NO.	DESCRIPTION	DATE	APP'D.
2	METAL TRUSS SCOPE REMOVED	02/17/16	
1	TITLE BLOCK REVISIONS

**REPAIRS TO NGIS BUILDING 225
DAM NECK ANNEX**

TRUSS FRAMING PLAN AREA "A"

TRUSS FRAMING PLAN-AREA "A"
1/8"=1'-0"

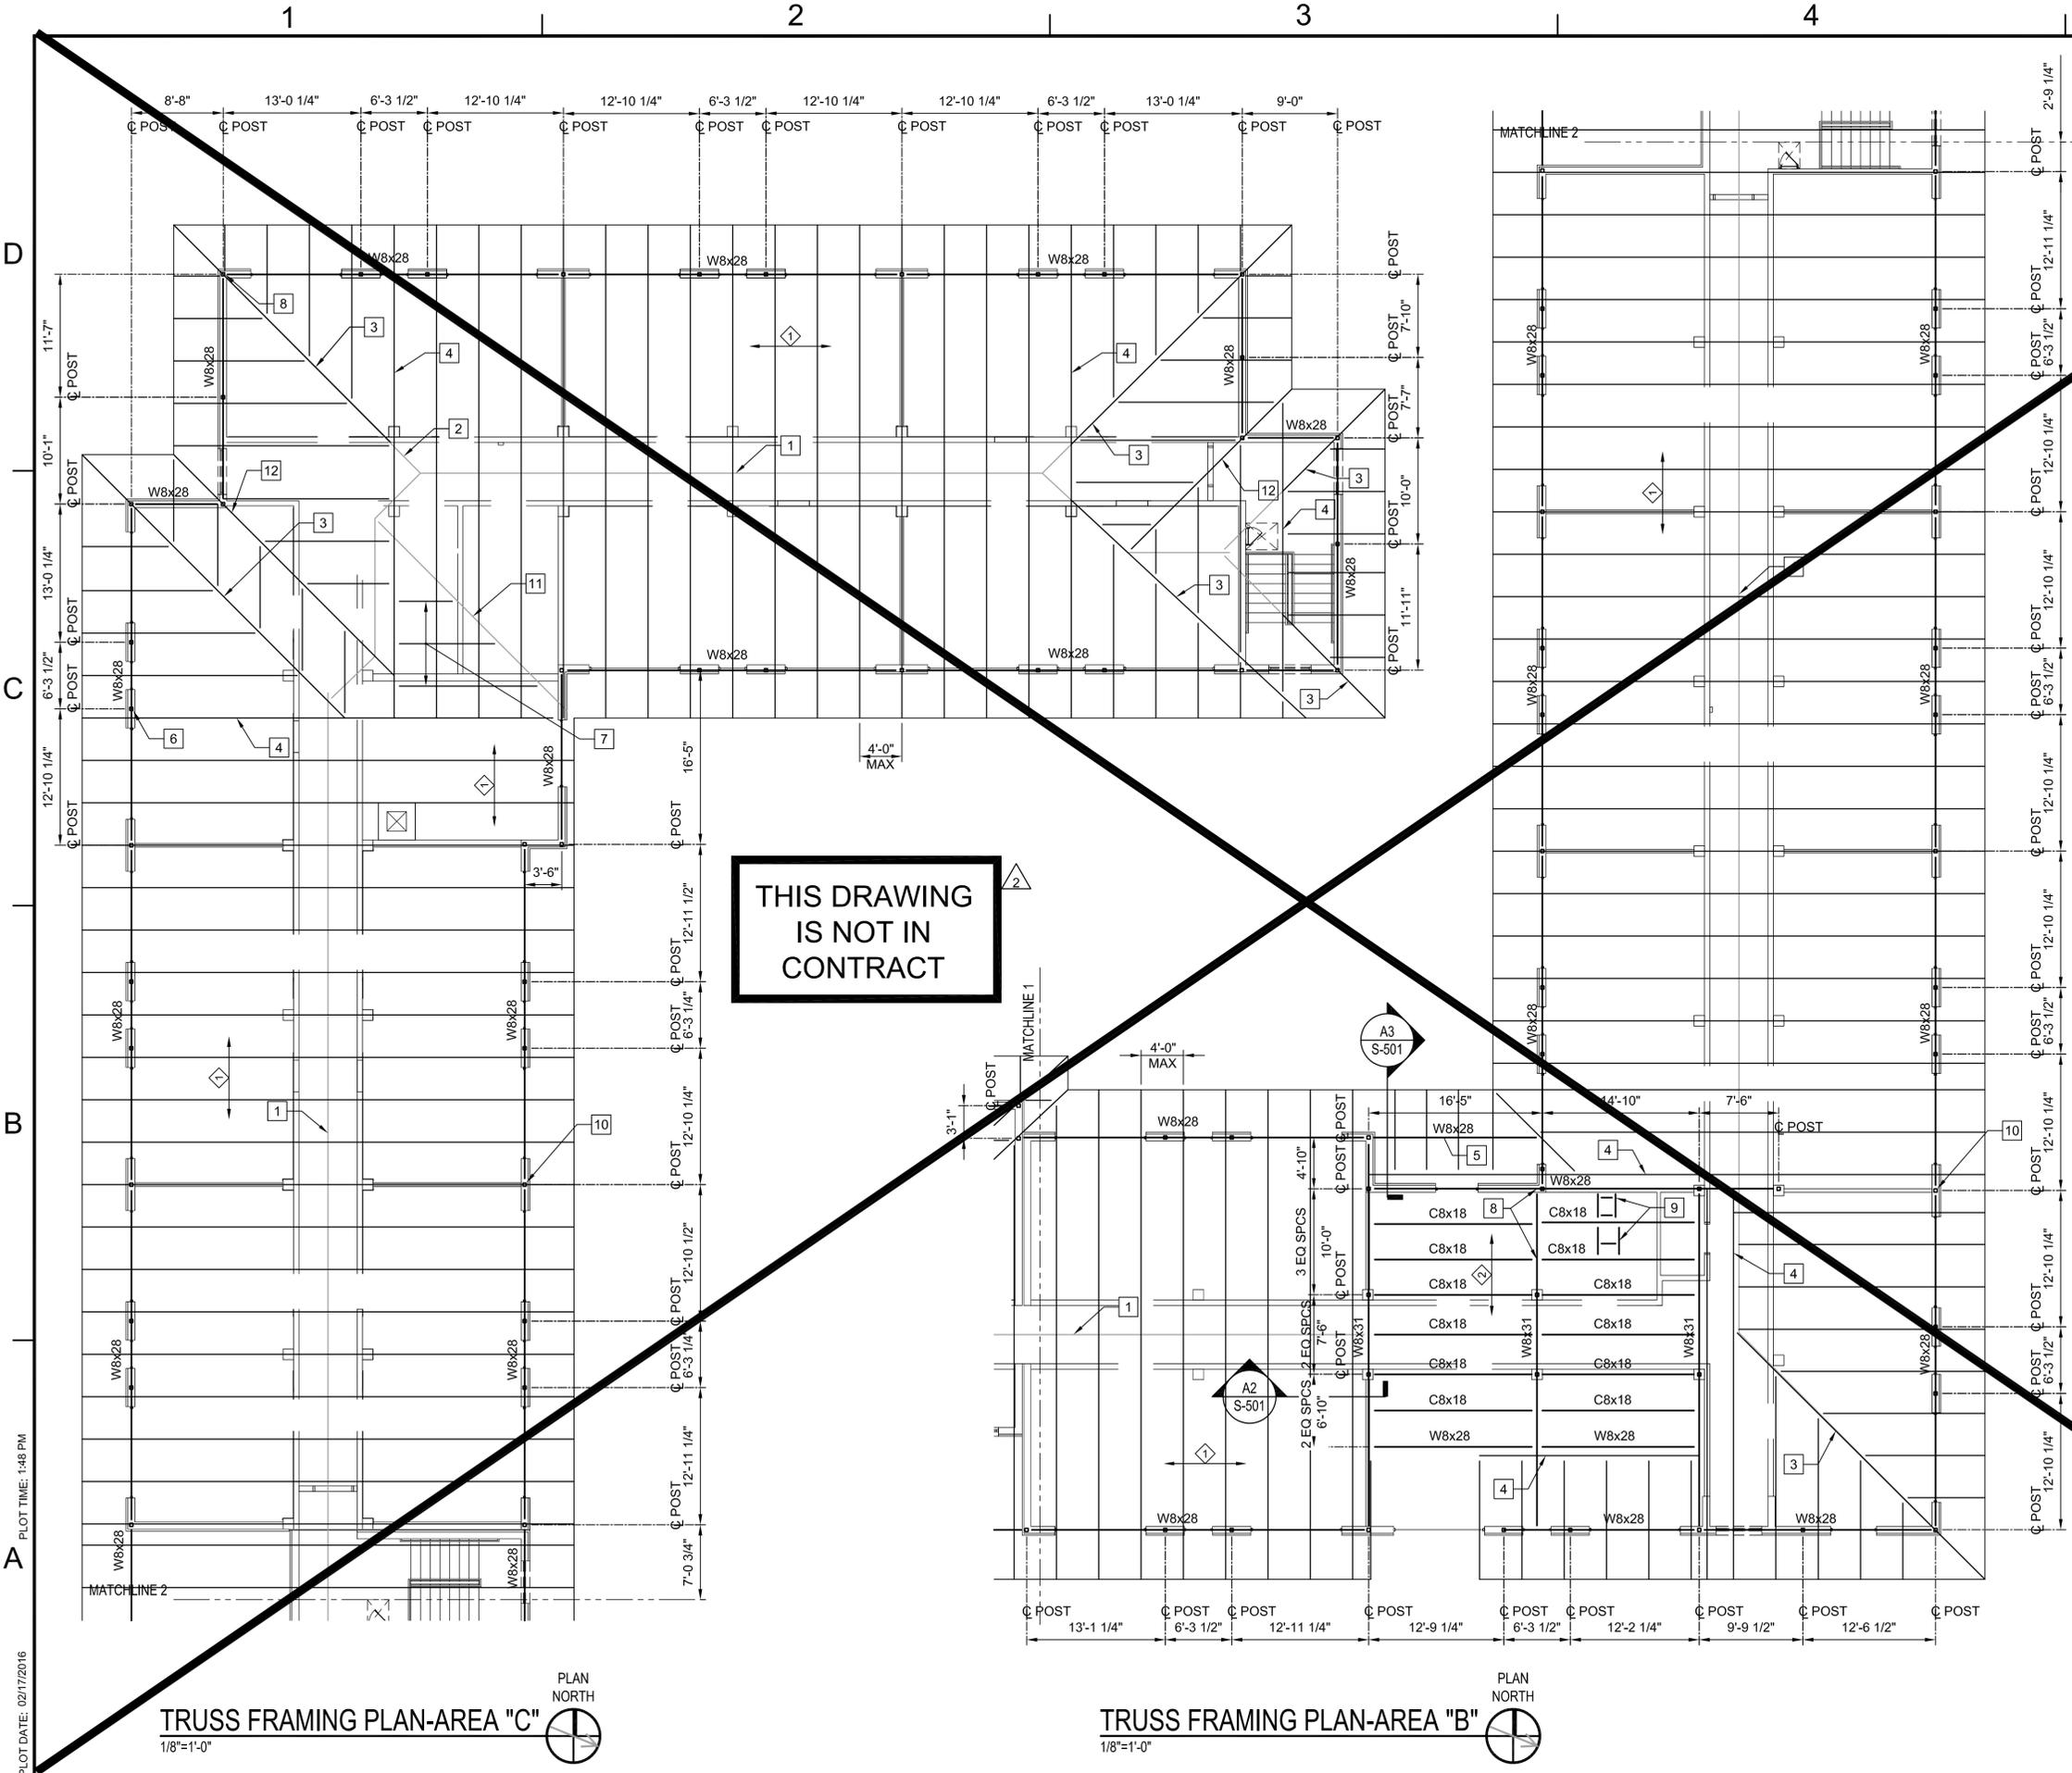
THIS DRAWING
IS NOT IN
CONTRACT

PENTHOUSE TRUSS FRAMING PLAN-AREA "B"

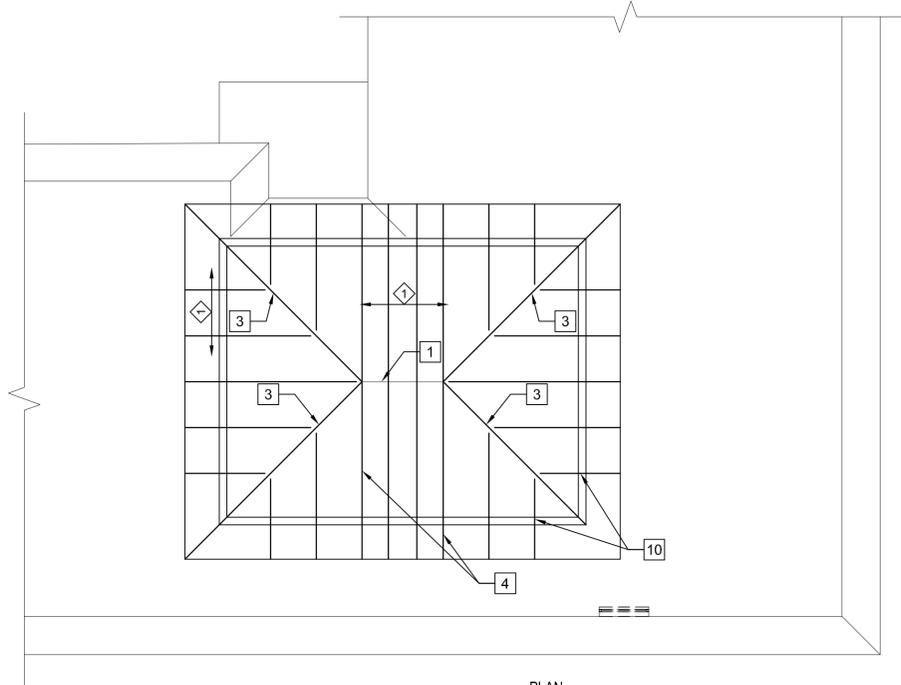
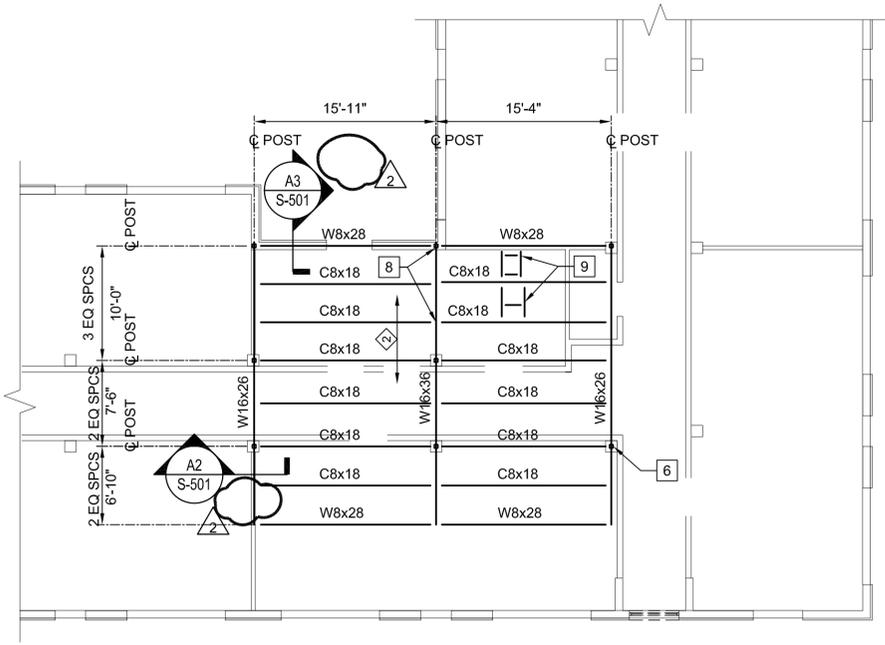
REV	DESCRIPTION	DATE
2	METAL TRUSS SCOPE REMOVED	02/17/16
1	TITLE BLOCK REVISIONS

ROOF PLAN EXISTING/DEMO

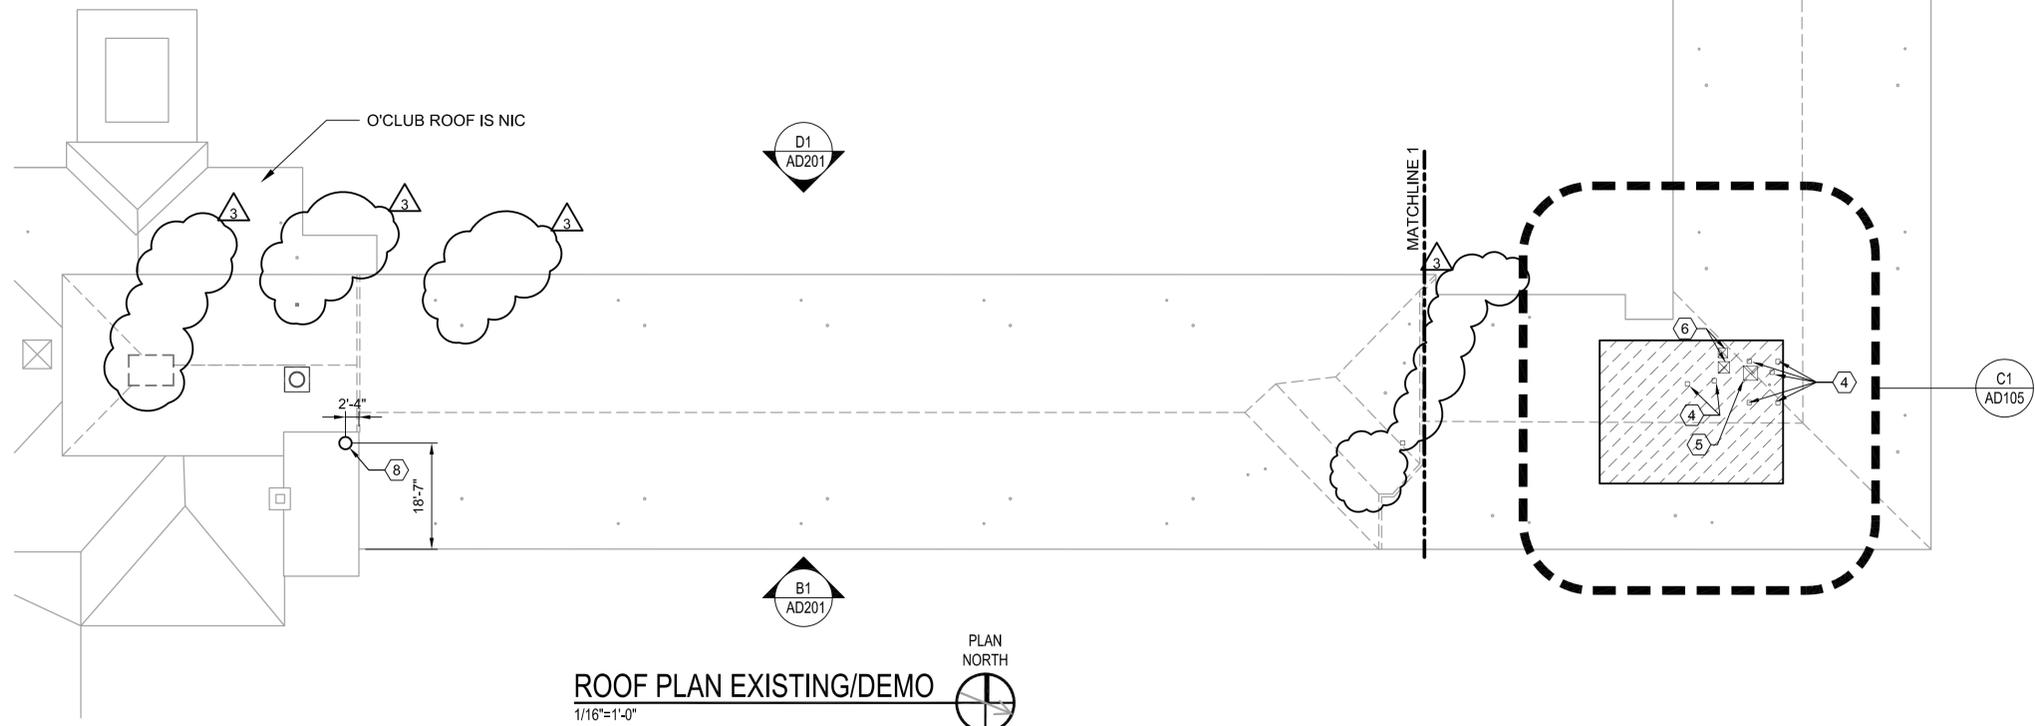
NO.	DESCRIPTION	DATE
3	METAL ROOF SCOPE REMOVAL	02/17/16
2	TITLE BLOCK REVISIONS	
1	MECH OPENINGS RELOCATED

ROOF PLAN
1/16" = 1'-0" PLAN NORTH

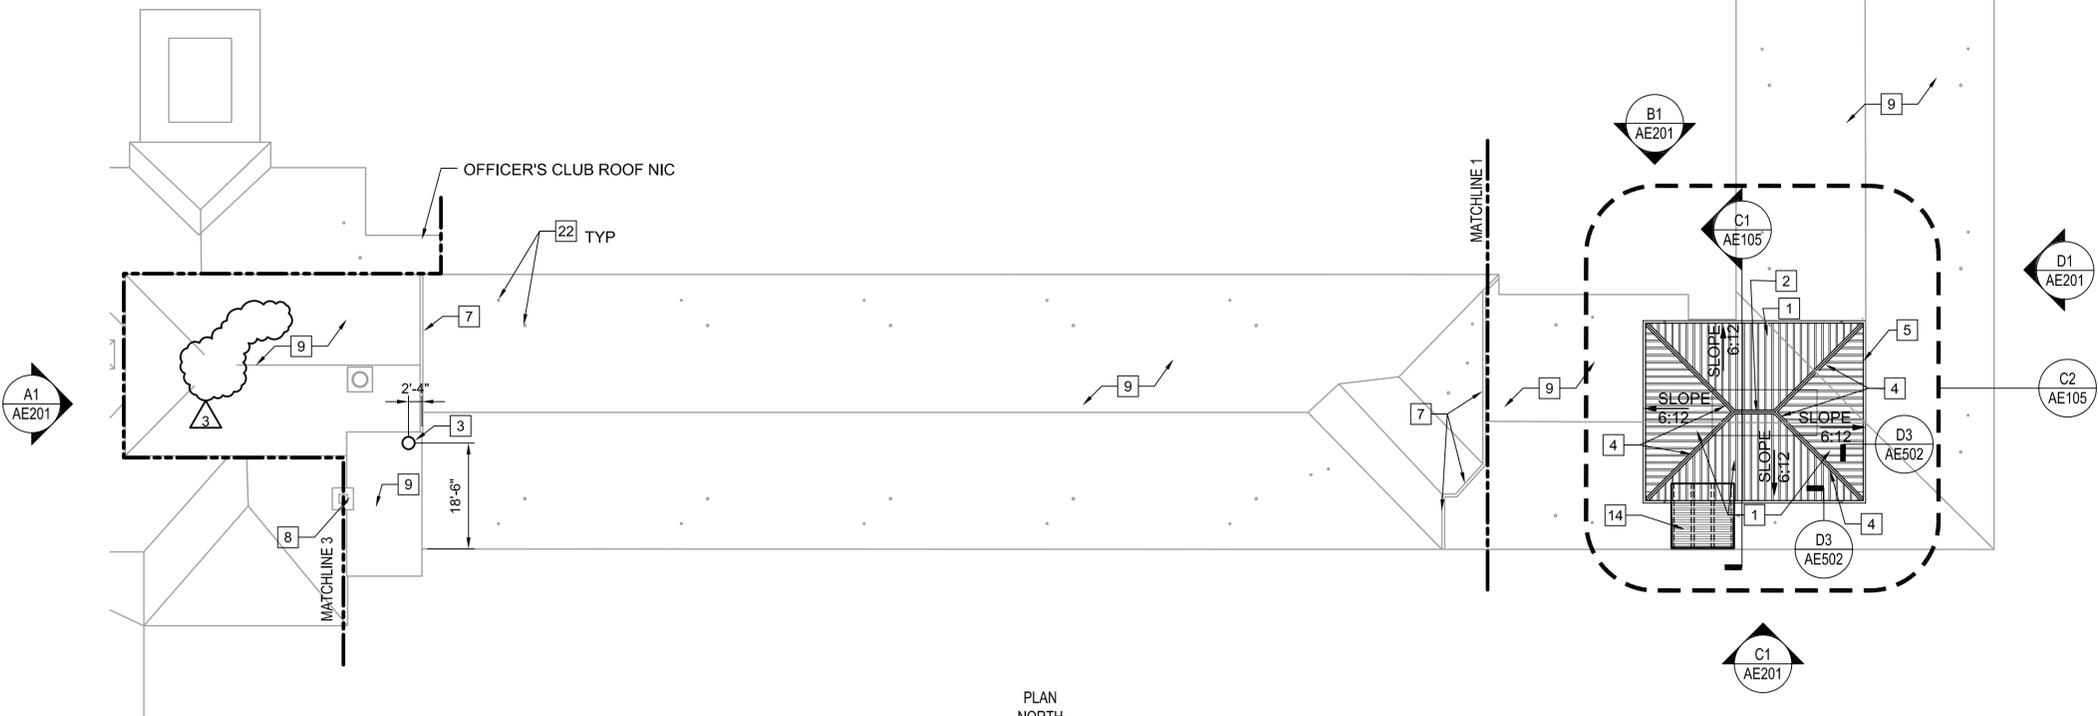
NO.	DATE	DESCRIPTION
3	02/17/16	METAL ROOF SCOPE REMOVAL
2		TITLE BLOCK REVISIONS
1		MECH OPENINGS SHIFTED
